AGENDA
CITY OF SEASIDE
PLANNING COMMISSION

A. BOARD OF ARCHITECTURAL REVIEW APPLICATION NO. BAR-22-05. JERRY L. WHITNEY, APPLICANT, AND AP GLOVER ENTERPRISES, LLC, OWNER, ARE REQUESTING DESIGN APPROVAL OF A 42-UNIT INFILL BUILDING REMODEL AND ASSOCIATED LANDSCAPE IMPROVEMENTS OF A FORMER NURSES BARRACKS LOCATED 4386 AND 4387 PARK FLATS CUT OFF ROAD IN THE HIGH DENSITY RESIDENTIAL (RH) ZONING DISTRICT (APN: 031-150-011). THE PROJECT MEETS ALL CRITERIA FOR A CLASS 32 CATEGORICAL EXEMPTION PURSUANT TO SECTION 15332 OF THE STATE CALIFORNIA ENVIRONMENTAL QUALITY ACT (CEQA) GUIDELINES AND DOES NOT MEET ANY OF THE EXCEPTIONS TO THE EXEMPTIONS.

A RESOLUTION OF THE PLANNING COMMISSION OF THE CITY OF SEASIDE, STATE OF CALIFORNIA, APPROVING ARCHITECTURAL REVIEW APPLICATION NO. BAR-22-05 FOR A 42-UNIT INFILL BUILDING REMODEL AND ASSOCIATED LANDSCAPE IMPROVEMENTS OF A FORMER NURSES BARRACKS LOCATED 4386 AND 4387 PARK FLATS CUT OFF ROAD IN THE HIGH DENSITY RESIDENTIAL (RH) ZONING DISTRICT (APN: 031-150-011). THE PROJECT MEETS ALL CRITERIA FOR A CLASS 32 CATEGORICAL EXEMPTION PURSUANT TO SECTION 15332 OF THE STATE CALIFORNIA ENVIRONMENTAL QUALITY ACT (CEQA) GUIDELINES AND DOES NOT MEET ANY OF T

SITE PLAN

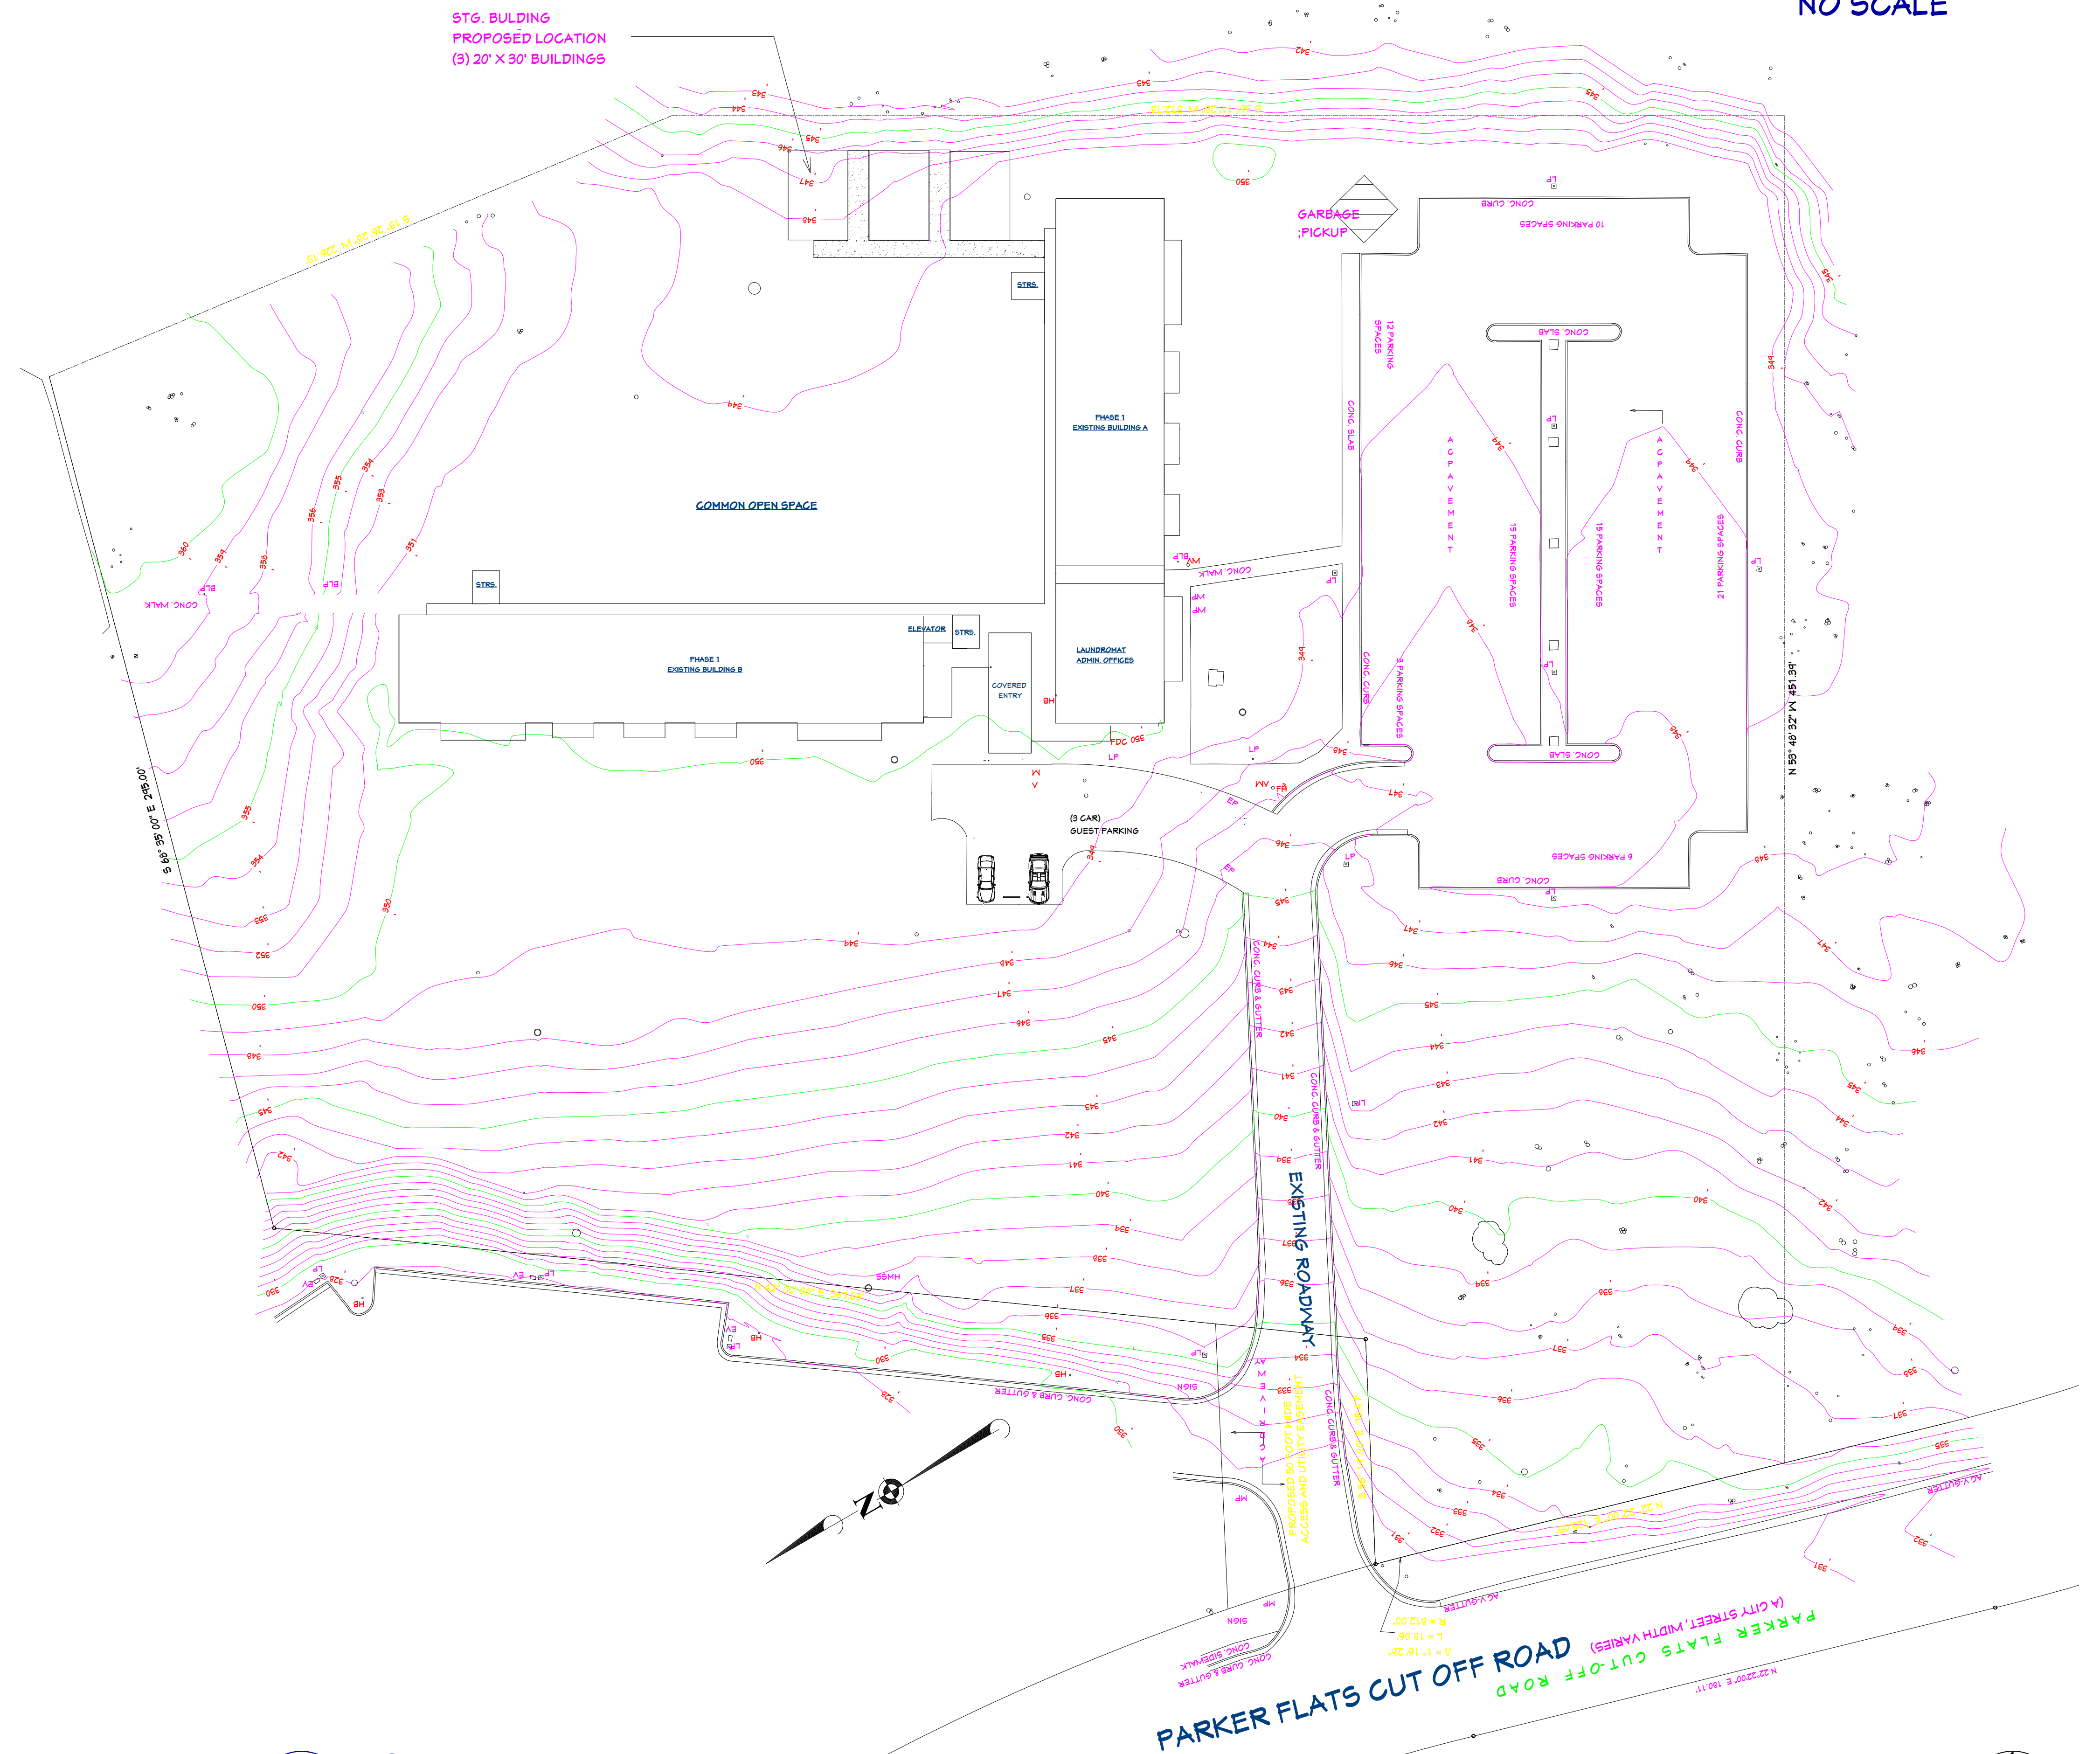
As described in the prior section, because the site already contains parking more than 10% in excess of the requirements, staff recommends reducing planned parking wherever advisable. One such area is to expand the safety zone around trash storage and removal. Elimination of the designated parking immediately adjacent to the designated trash site may increase traffic flow, decrease resident proximity to an odorous area, and reduce the potential for crashes or disruptions due to trash pickup.

1. Show all eight charging stations on the site plan.
2. Remove excessive parking from the backup area of the trash facility.
3. Remove one parking space immediately adjacent to the trash facility.
4. Install short-term bicycle parking racks that meet APBP guidelines.
5. Install six long-term bicycle parking spaces.

3. The perimeter of the larger parking area shall include more perimeter landscaping than currently shown on the landscape plan. Plantings to be shown on the landscape plans submitted for building permit review and to be approved by Planning.

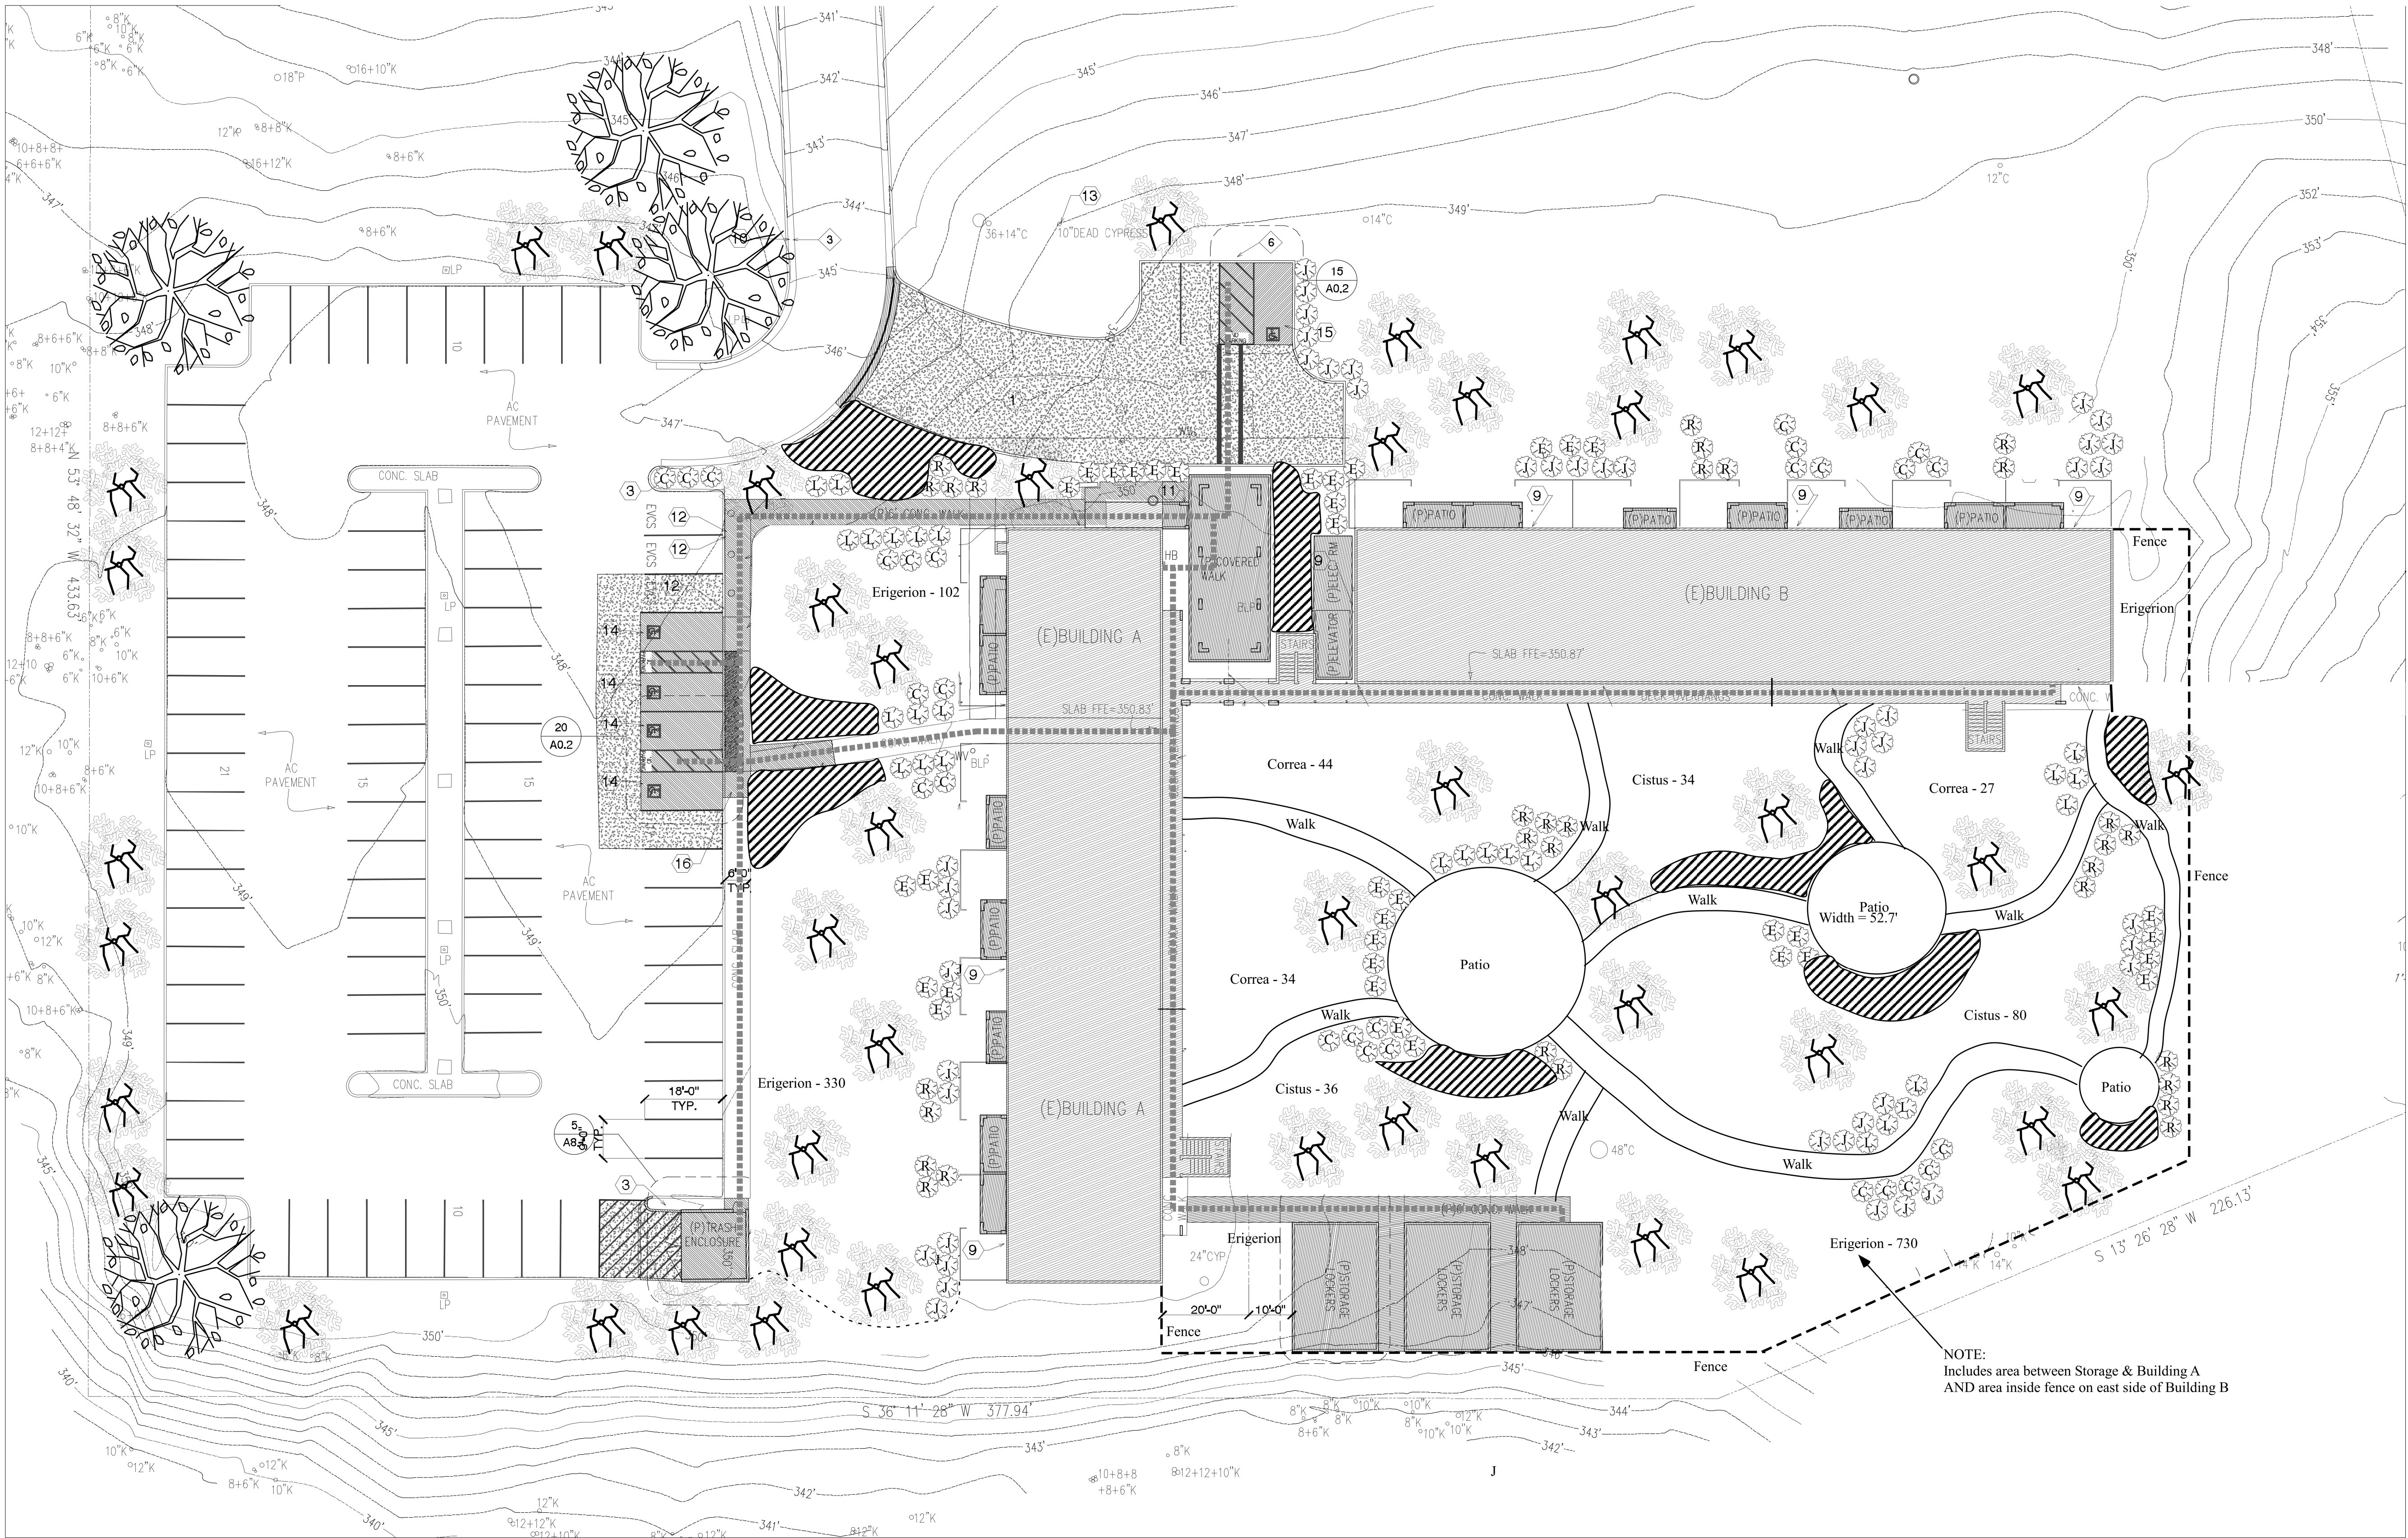
The proposed site landscaping area greatly exceeds the code requirement of SMC 17.52.180.X.1, Table 4-1 *Multifamily Project Open Space Requirements* specifies a project of 11 or more units provide a minimum of common open space of 100sf per unit or 4,200 sf of required landscape area. The approximate area of the interior courtyard landscaping alone is more than 25,725 sf. This large area is proposed to be planted with a total of 50, 15 gal. trees; and 159, 5gal. and 1 gal. shrubs; and 213, 1 gal. perennials; and more than 1,200 groundcovers of three different species. The SMC encourages the planting of native and/or drought tolerant species, but as proposed the Monterey Cypress (qty. 4) is the only California native. Many of plants have a "Low"

rating according to WUCOLS (Water Use Classification of Landscape Species). See Attachment 3 for Native Plant List, from which the applicant is required to select at least two additional trees species as specified in a condition of approval.

4. The Monterey Cypress trees shall be a minimum of 6' tall, measure from grade after planting.
5. At least four different tree species are required and shall be listed and depicted on the landscape plans submitted for building permit review. See Attachment 4 for Native Plant list.
